10 July 2020

Richland Parks and Recreation Building | City of Richland  
WBA Project No. 2619

## ADDENDUM NO. 03

**MEZZANINE FRAMING PLAN - GYMNASIUM**  
1/8" = 1'-0"

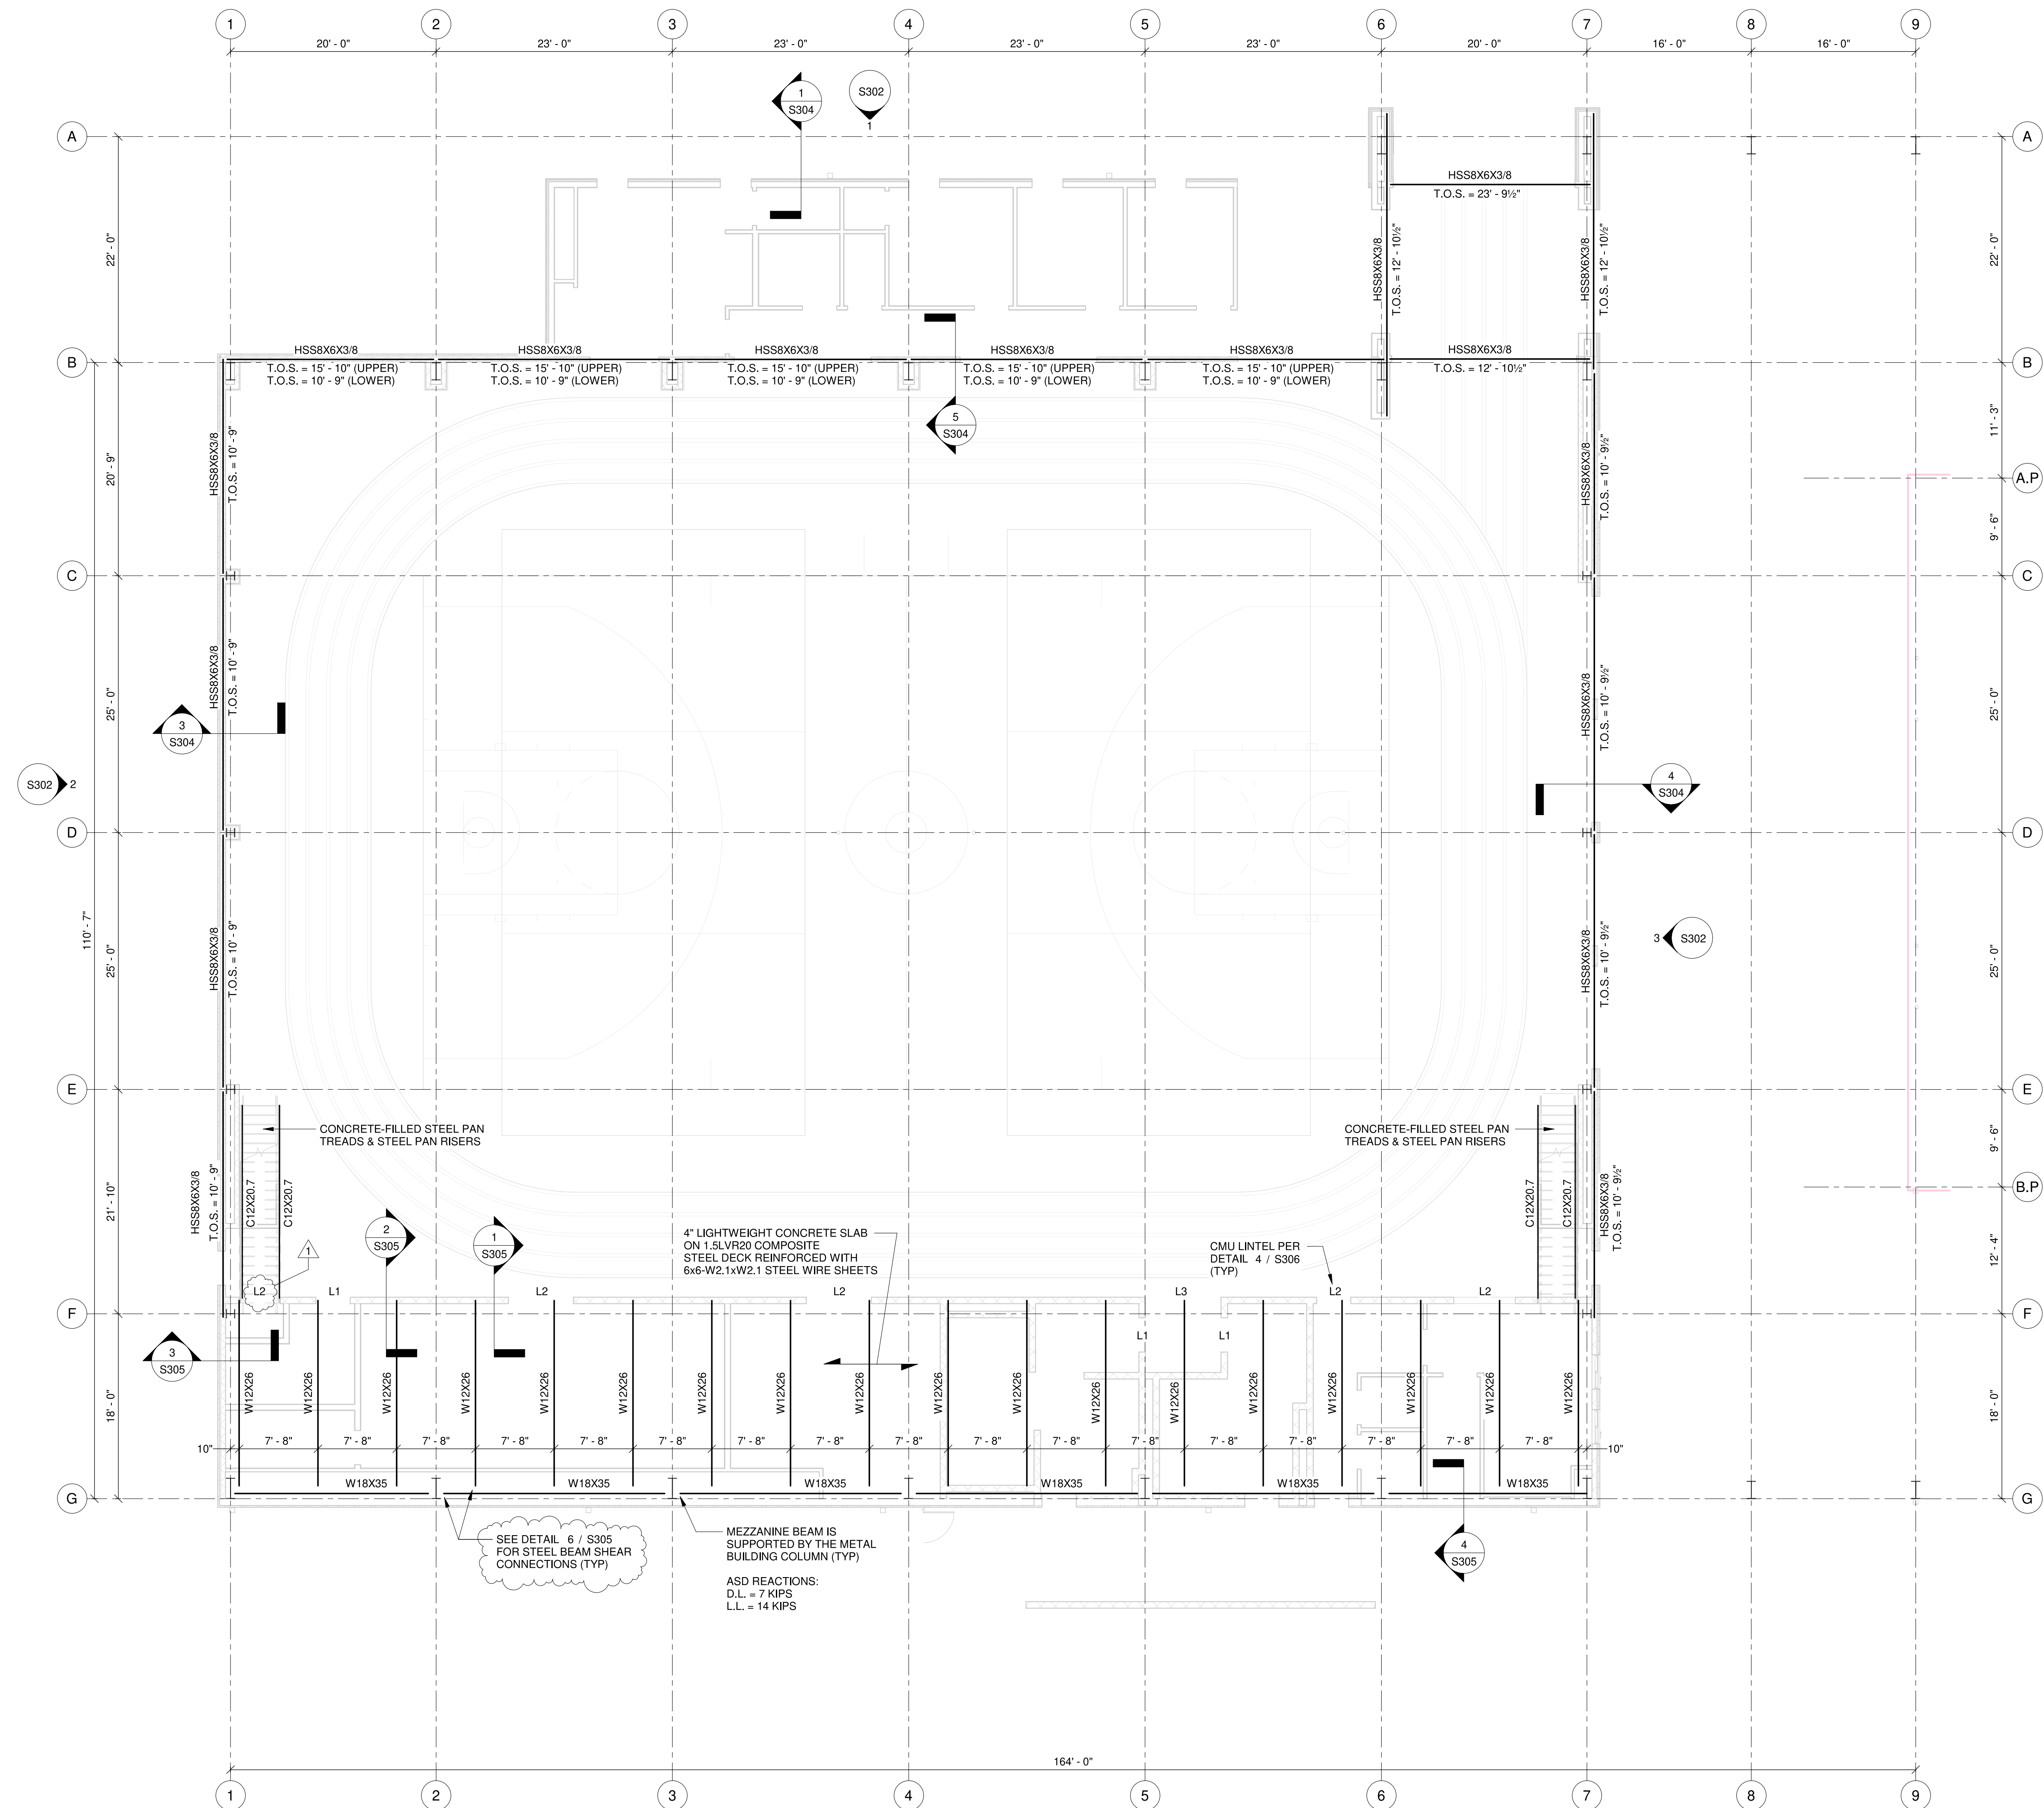
- ITEM NO. 12**      **SHEET S202 MEZZANINE FRAMING PLAN - GYMNASIUM**  
**DELETE** sheet in its entirety and **REPLACE** with enclosed sheet. **ADD** clarification about steel beam  
shear connections.

**6**  
S300 FOUNDATION SECTION AT ENDWALL FOOTING  
3/4" = 1'-0"

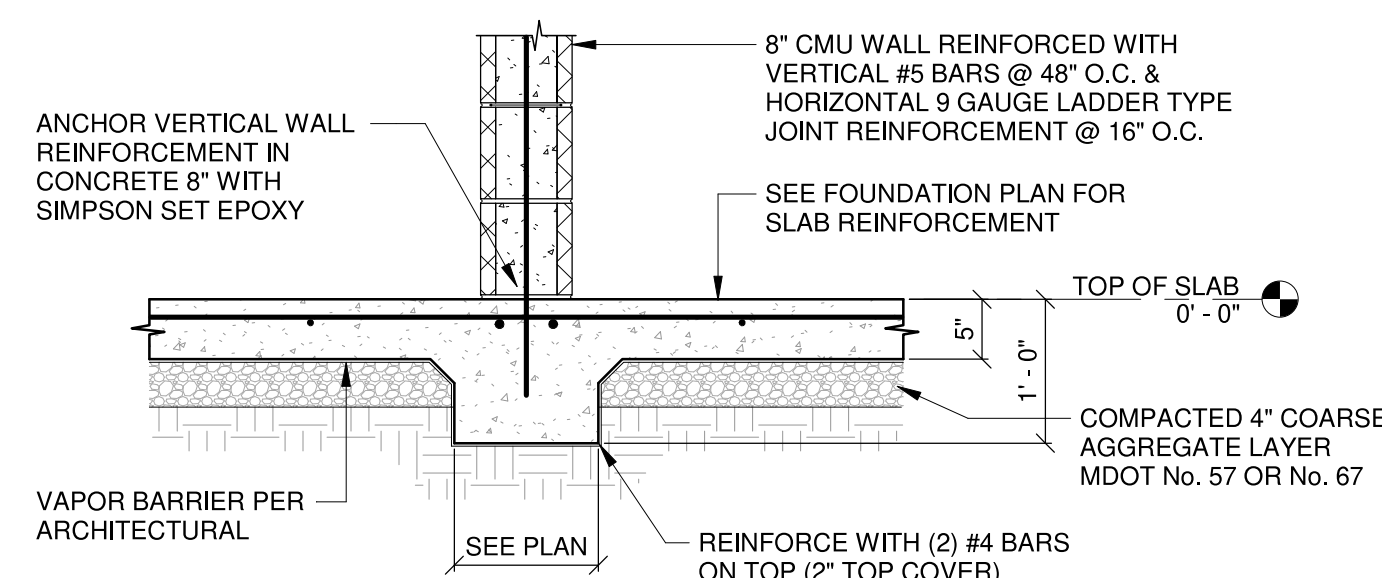
- ITEM NO. 13**      **SHEET S300 DETAILS**  
**DELETE** sheet in its entirety and **REPLACE** with enclosed sheet. **REVISE** detail 6/S300.
- ITEM NO. 14**      **SHEET S301 DETAILS**

**1** EXTERIOR COLUMN FOOTING SECTION  
S301 3/4" = 1'-0"

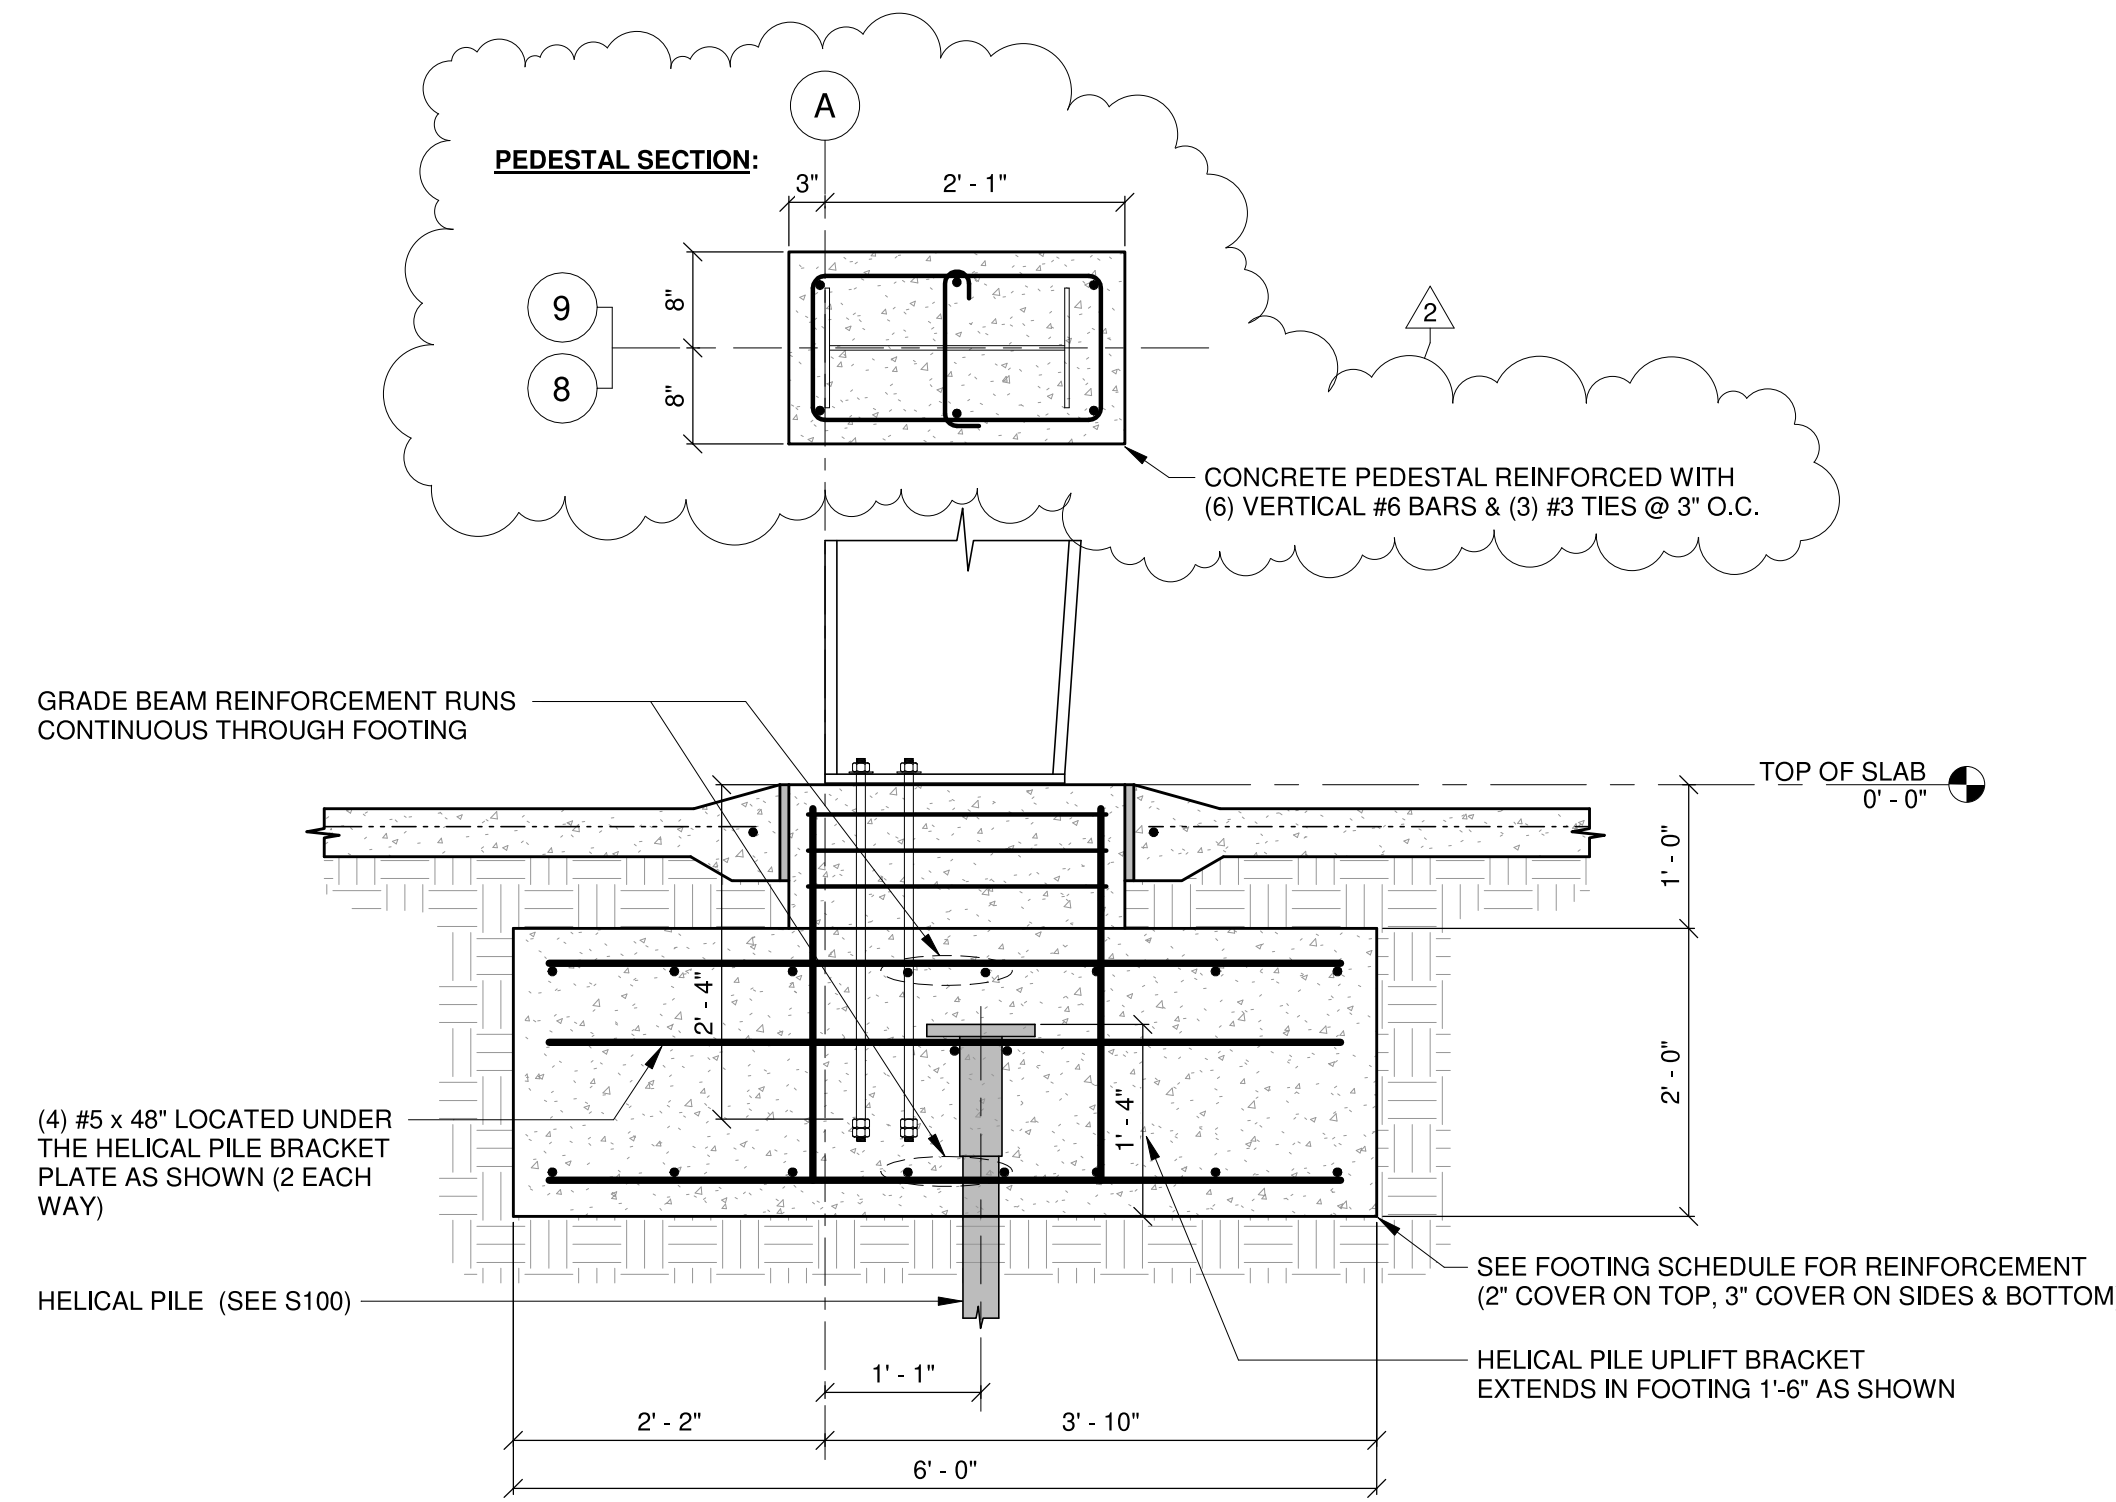
**DELETE** sheet in its entirety and **REPLACE** with enclosed sheet. **REVISE** detail 1/S301.
- ITEM NO. 15**      **SHEET S303 DETAILS**  
**DELETE** sheet in its entirety and **REPLACE** with enclosed sheet. **ADD** plan detail for exterior slab  
(2/S303).

**6** STEEL BEAM SHEAR CONNECTIONS  
S305 1" = 1'-0"

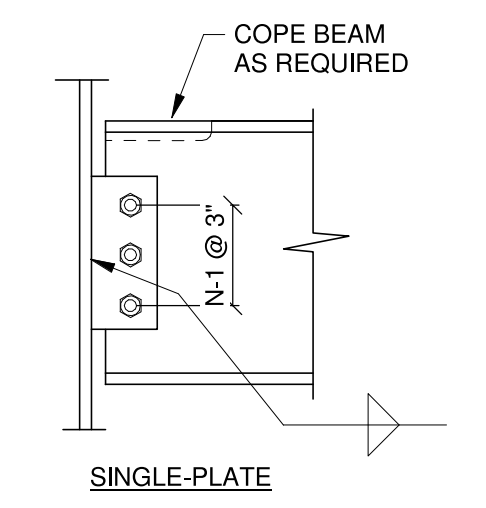
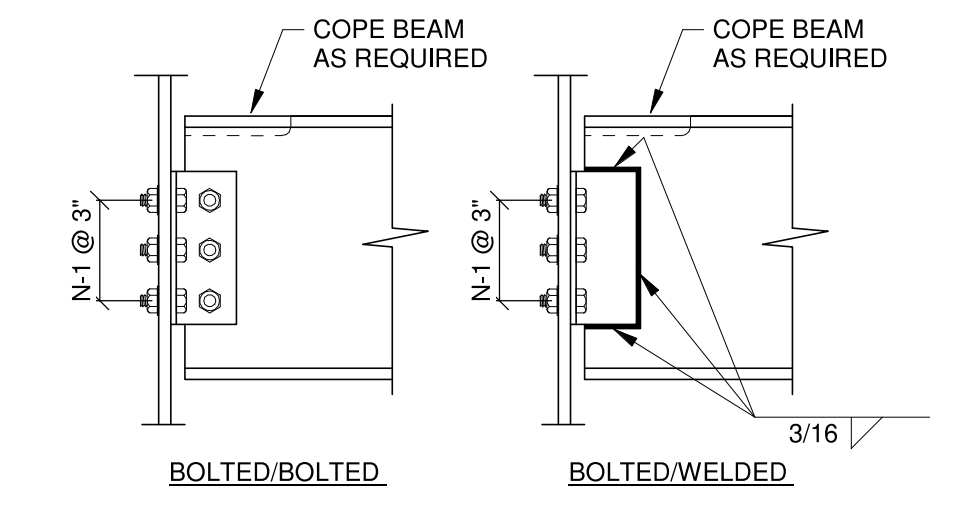
- ITEM NO. 16**      **SHEET S305 DETAILS**  
**DELETE** sheet in its entirety and **REPLACE** with enclosed sheet. **ADD** steel beam shear connections  
schedule (6/S306).

1 SINGLE LINE DIAGRAM  
E0.0 Scale: NONE

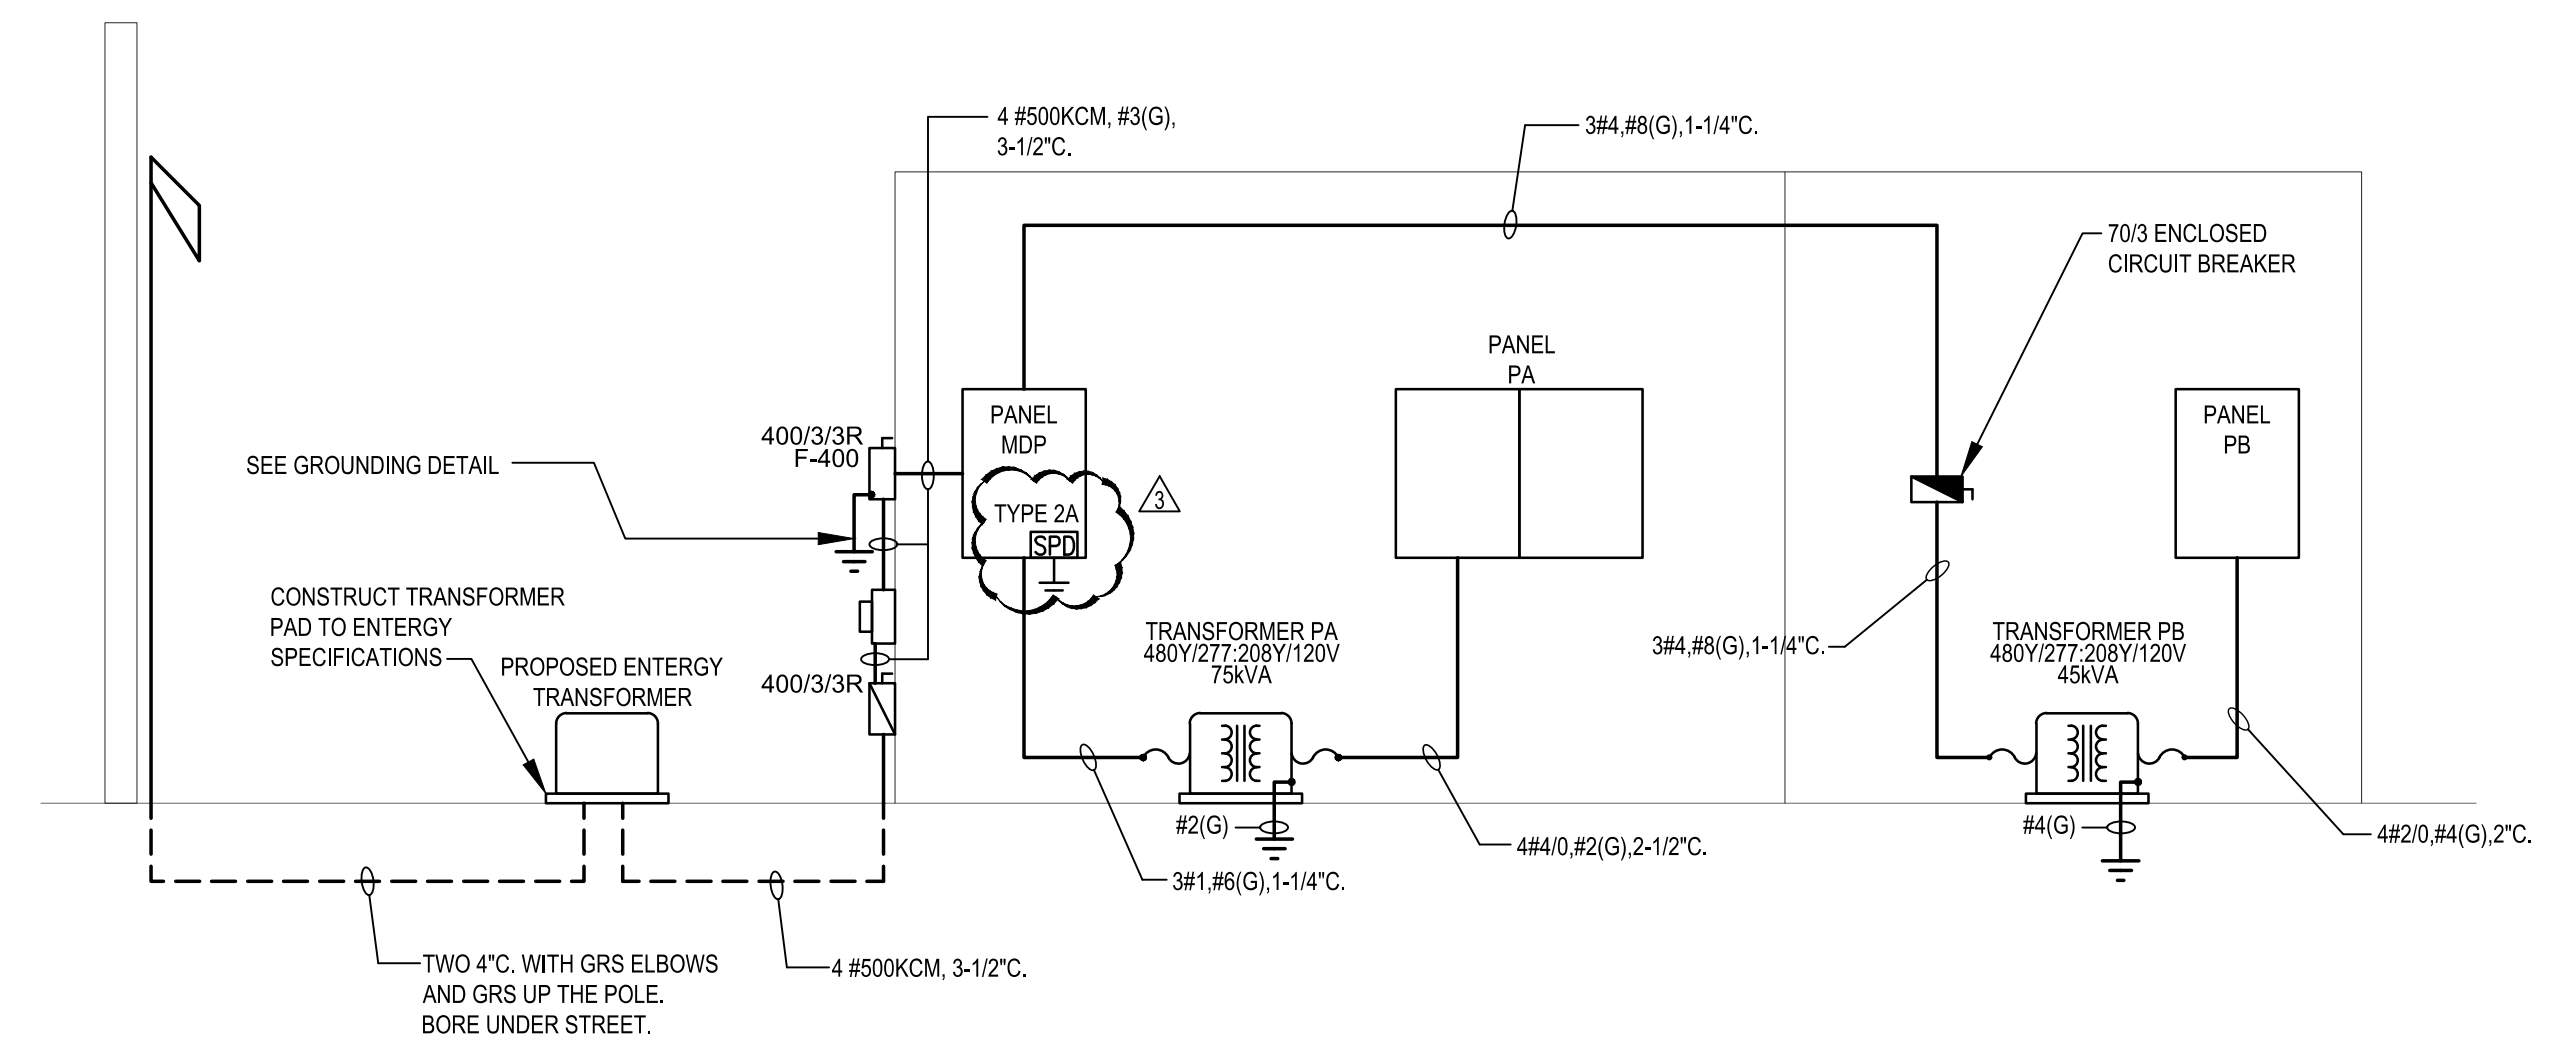
- ITEM NO. 17**      **SHEET E0.0 ELECTRICAL LEGEND**  
**DELETE** sheet in its entirety and **REPLACE** with enclosed sheet. **REVISE** single line diagram.
